Agenda Item # 8

BOA-003603-2026

Location:
59 Batre Lane

REQUEST Front Yard Setback and Site Coverage Variances

SITE PLAN

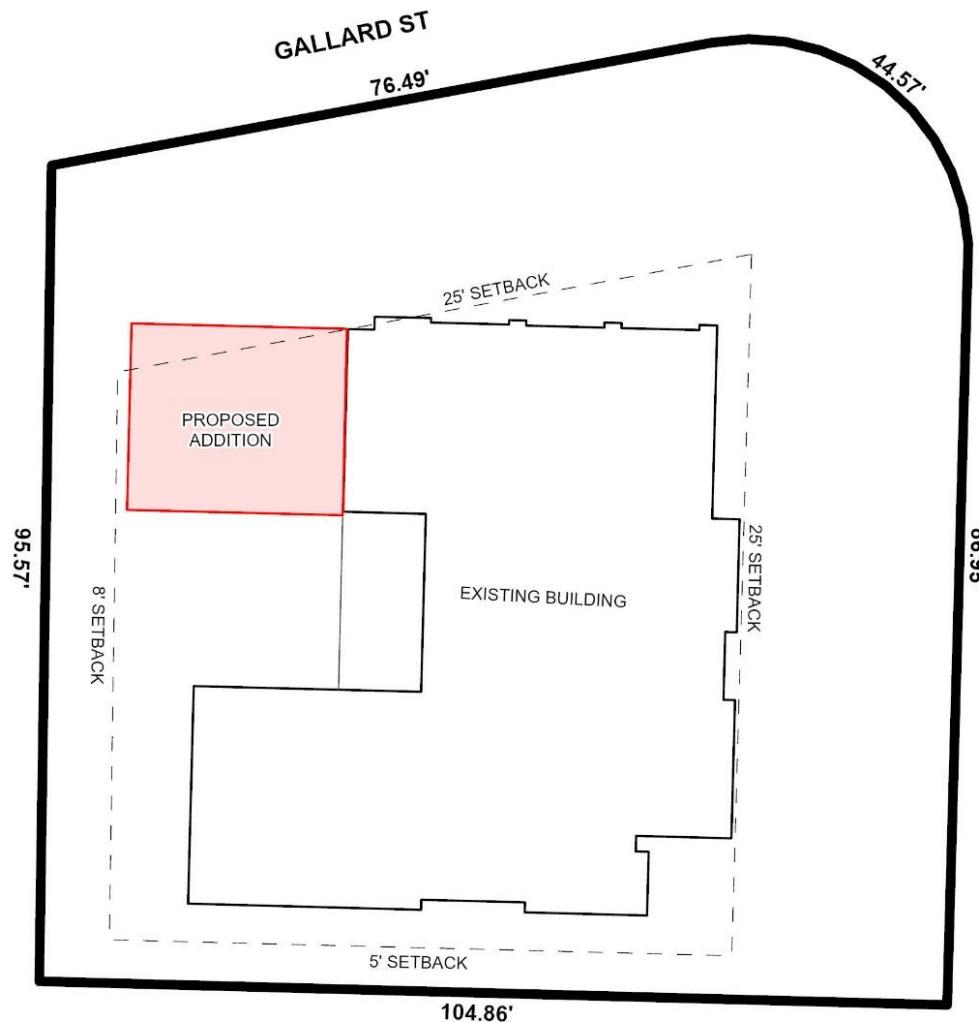
The subject property is a corner lot with frontage along both Gallard Street and Batre Lane and was recorded with 25-foot minimum building setbacks along both street frontages. The proposed covered/screened porch would encroach approximately five-feet and five-inches (5' 5") into the required setback along Gallard Street, and an existing seven-foot-tall brick wall was build to the property line along Gallard Street per the provided survey of the property.

The submitted site plan illustrates the existing dwelling and proposed placement of the covered/screened porch. The site plan does not show both the covered/screened porch and the masonry wall together. Should the variance be approved, staff recommends that a revised site plan or property survey be submitted to confirm the wall's precise location as well as the covered/screened porch relative to property lines.

- 1) Revision of the site plan to illustrate all location of the masonry wall;
- 2) Acquisition of all required permits and inspections for the screened porch;
- 3) Acquisition of all necessary permits for the construction of the wall; and
- 4) Compliance with all other codes and ordinances.
